## SERVICE BULLETIN

**APPLICABILITY:** 2020-23MY Legacy & Outback  
 2023MY Ascent

**NUMBER:** 07-213-22R

**SUBJECT:** Genuine Battery Replacement

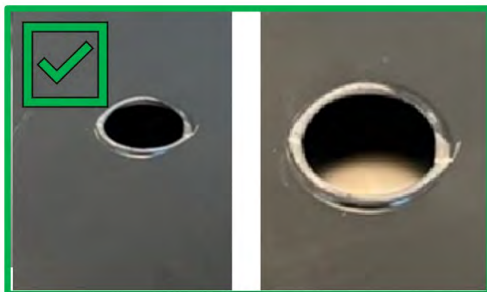
- A. CAREFULLY** cut off and trim the two protrusions on the bottom of the battery tray. This will allow a proper fit when installed. Try to make the cut as flush as possible.

Remaining Height Is More Than 2mm

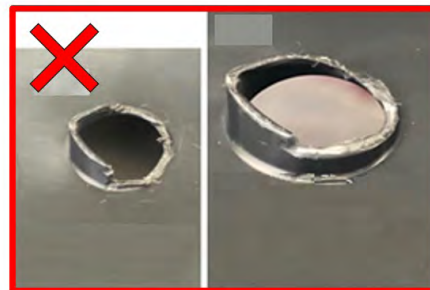
**CAUTION:** Be sure the protrusions are trimmed flush. The remaining protrusion height **MUST** be less than 2mm to provide proper fitment.
